Re: LC 73 – Portland General Electric Company’s Reply Comments

Docket LC 73

2019 Integrated Resource Plan.

REPLY COMMENTS

Figure 1. Solar ELCC Comparison⁷¹

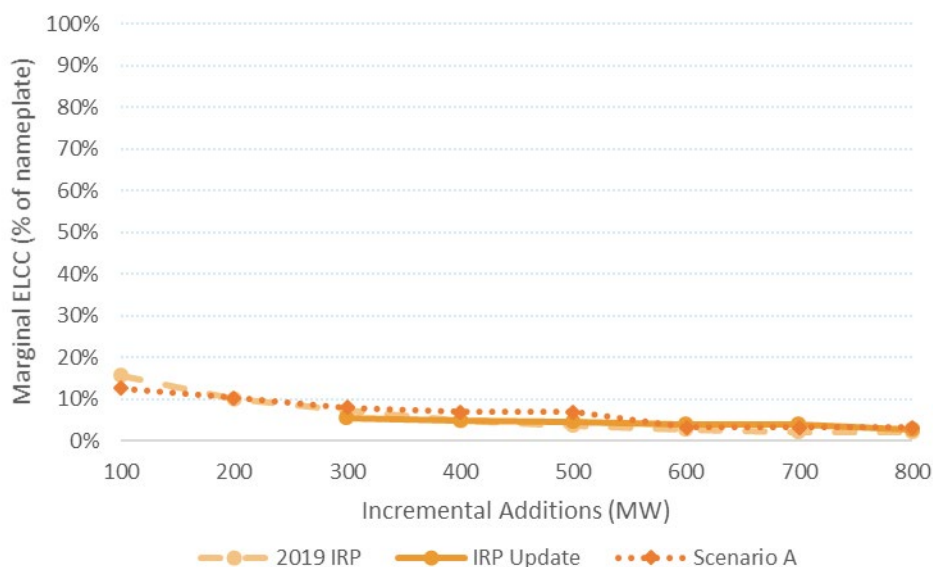
Staff expressed an interest in better understanding the ELCC value of solar in the context of the updated market capacity assumptions, the loss-of-load expectation heatmap from the IRP Update (Figure 8 in the IRP Update), and the E3 regional capacity study seasonal solar ELCC values.⁶⁰ Staff also noted that they would like “to explore further whether PGE’s capacity contribution values are dependent on its choice of the reference year 2025 for its modeling.”⁶¹

In the Section 5.3 of the 2019 IRP Update, PGE noted that the ELCC value for the first increment of additional solar resources decreased relative to the first increment of additional resources in the 2019 IRP ELCC study primarily because of a material increase to the quantity of solar resources in the Baseline Portfolio (approximately 200 MW). The approximately 200 MW of increased solar resources is the net change to the portfolio due to both resource additions and terminations since the 2019 IRP. The resource additions included the first GEAR offering (162 MW), the CSP (approximately 93 MW) and solar QF contracts (approximately 95 MW).⁶⁵ These were partially offset by solar QF terminations, including anticipated terminations associated with the Community Solar Settlement Agreement.⁶⁶

The ELCC studies in the 2016 IRP, 2016 IRP Update, and 2019 IRP all found that the ELCC value of solar resources declined as more solar resources were added to the portfolio. This is consistent with the finding of the IRP Update. As expected from the 2019 IRP ELCC study, the first increment of solar resources for the IRP Update has a lower ELCC value than the first increment of resources in the study for the 2019 IRP (5.5 percent compared to 15.8 percent). A more appropriate comparison, however, is between the first increment of the IRP Update and the third increment of the 2019 IRP (5.5 percent and 7.2 percent) because these have approximately the same quantity of solar resources in the portfolios. For the 100 MW increments examined, this is a difference of less than 2 MW.⁶⁷ **Table 1** compares the ELCC values from the IRP Update with those values from the 2019 IRP that were based on a similar quantity of solar resources.

In order to provide additional insight into the impact of the increase in solar resources in the Baseline Portfolio, PGE conducted new analysis for a scenario that examined the impact on ELCC values if 200 MW of solar resources were removed from the Baseline Portfolio. **Figure 1** compares the ELCC values for solar from the 2019 IRP, the IRP Update, and the scenario (labeled Scenario A in the figure). The figure aligns the ELCC values based on the approximate quantity of solar resources in each study. Scenario A showed a similar pattern to the 2019 IRP, with a higher initial ELCC value for solar than the IRP Update (as expected due to the reduction of solar in the portfolio compared to the IRP Update), and a declining value for the next increments.

Figure 4. Draft 2022 IRP Overnight Capital Costs from Roundtable 21-1¹¹⁹

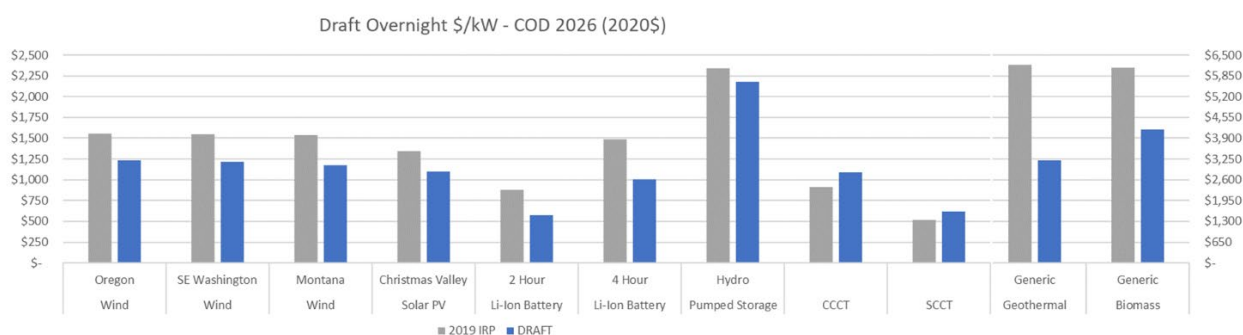
NewSun requested that PGE provide draft Schedule 201 prices and the pricing workbook in the IRP process.¹¹⁷

PGE further notes that as shared during Roundtable 21-1 (and included in **Figure 4**), draft resource cost information for the 2022 IRP indicates a material decline of the forecasted overnight capital costs for wind and solar resources compared to the 2019 IRP, with a slight increase to the cost of a simple-cycle combustion turbine. This indicates that even if the inputs from this IRP Update are included in the May 1 price update, PGE customers may continue to pay inflated prices to QF developers for resources PGE could likely procure at lower costs. However, given that the work on these draft resource cost and performance reports have not been finalized, PGE did not include it in this IRP Update.¹¹⁸
